Work Order ID 85381

DART SERVICE INSTRUCTION

TO AMEND INSTALLATION INSTRUCTIONS IIN-D412-698 REV. E OR LATER APPROVED REVISION
AND ICA-D412-698 REV. 5 OR LATER APPROVED REVISION

DESIGN	<i>[Signature]</i>	DART AEROSPACE LTD HAWKESBURY, ONTARIO, CANADA	
DRAWN	<i>[Signature]</i>		
CHECKED	<i>AJS</i>	DRAWING NO.	REV. C
MFG. APPR.	<i>N/A</i>	DSI 9484	SHEET 2 OF 3
APPROVED	<i>[Signature]</i>	TITLE	
DE APPR.	<i>[Signature]</i>	D412-698-027/-028/-037/-038 Kits NTS	
DATE	11.03.21	COPYRIGHT © 2009 BY DART AEROSPACE LTD THIS DOCUMENT IS PRIVATE AND CONFIDENTIAL AND IS SUPPLIED ON THE EXPRESS CONDITION THAT IT IS NOT TO BE USED FOR ANY PURPOSE OR COPIED OR COMMUNICATED TO ANY OTHER PERSON WITHOUT WRITTEN PERMISSION FROM DART AEROSPACE LTD.

FIGURE 2: D3675-5/-6 BRACKET INSTALLATION ON COMPOSITE DOORS
(-6 SHOWN, -5 OPPOSITE)

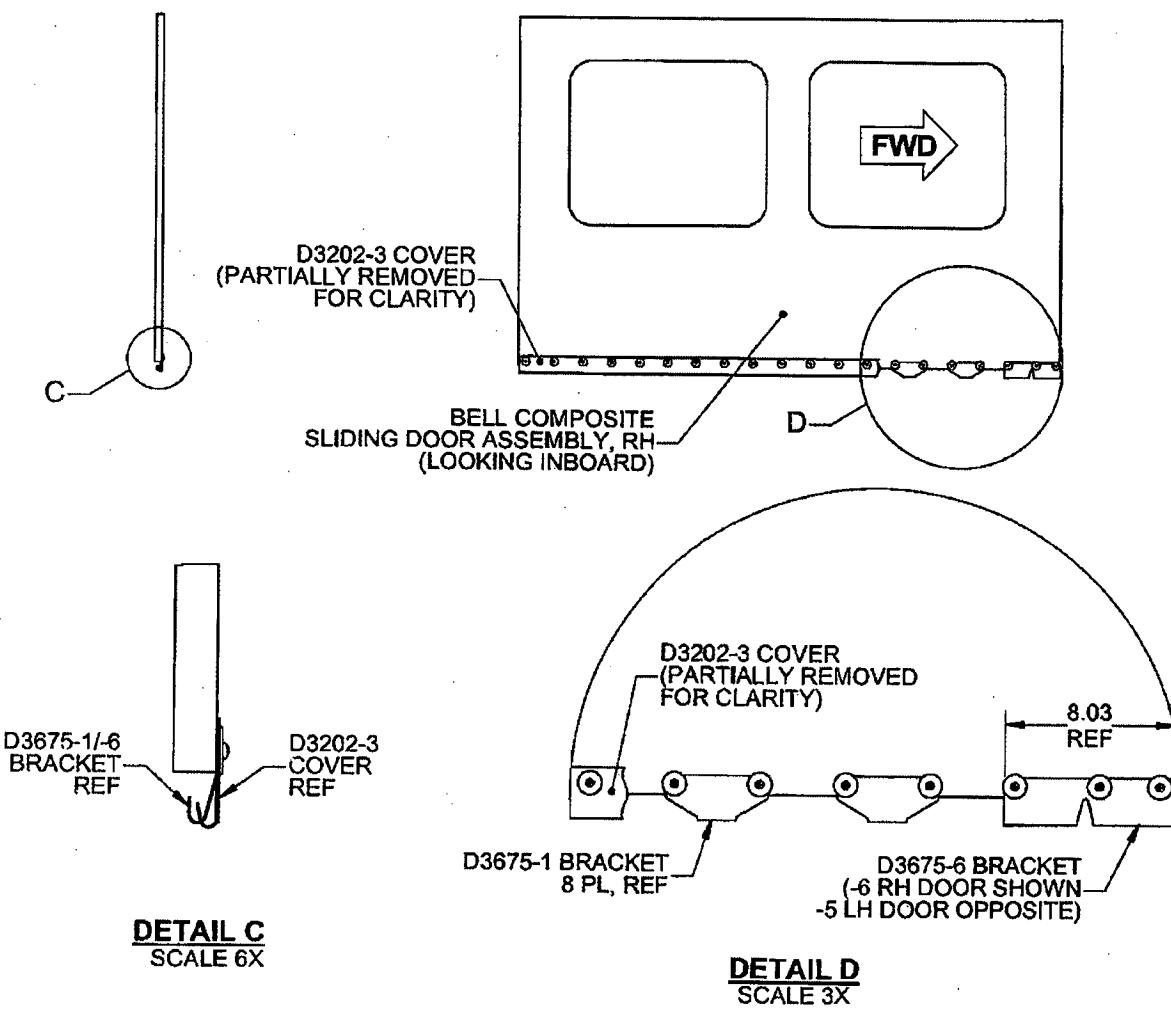
Field experience has shown that the forward D3199-1 brackets that are part of the D412-698-011/-012/-017 Cabin Door Roller Kits and forward D3675-1 brackets that are part of the D412-698-031/-032/-033 Cabin Door Roller Kits may wear prematurely if the aircraft is flown a significant amount of time with the sliding doors open. Dart has developed the D412-698-027/-028 kits that includes a longer D3199-3/-4 bracket for installation in the first forward position of the D412-698-011/-012/-017 kits to reduce wear on these forward brackets on aircraft equipped with aluminum doors. Likewise, Dart has developed the D412-698-037/-038 kits that includes a longer D3675-5/-6 bracket for installation in the first forward position of the D412-698-031/-032/-033 kits to reduce wear on these forward brackets on aircraft equipped with composite doors.

- 1) Remove the sliding door from the aircraft per Section 52.1 of ICA-D412-698
- 2) Remove the first forward D3199-1 or D3675-1 brackets as applicable.
- 3) Install the D3199-3/-4 or D3675-5/-6 bracket as applicable in lieu of the removed -1 bracket. Refer to Figure 1 Sheet 2 (aluminum doors) or Figure 2 Sheet 3 (composite doors).
- 4) Torque hardware per ICA-D412-698.
- 5) Re-install sliding door on aircraft per Section 52.2/52.3 of ICA-D412-698 as applicable.
- 6) Make entry in technical records of aircraft indicating that DSI 9484 has been completed.
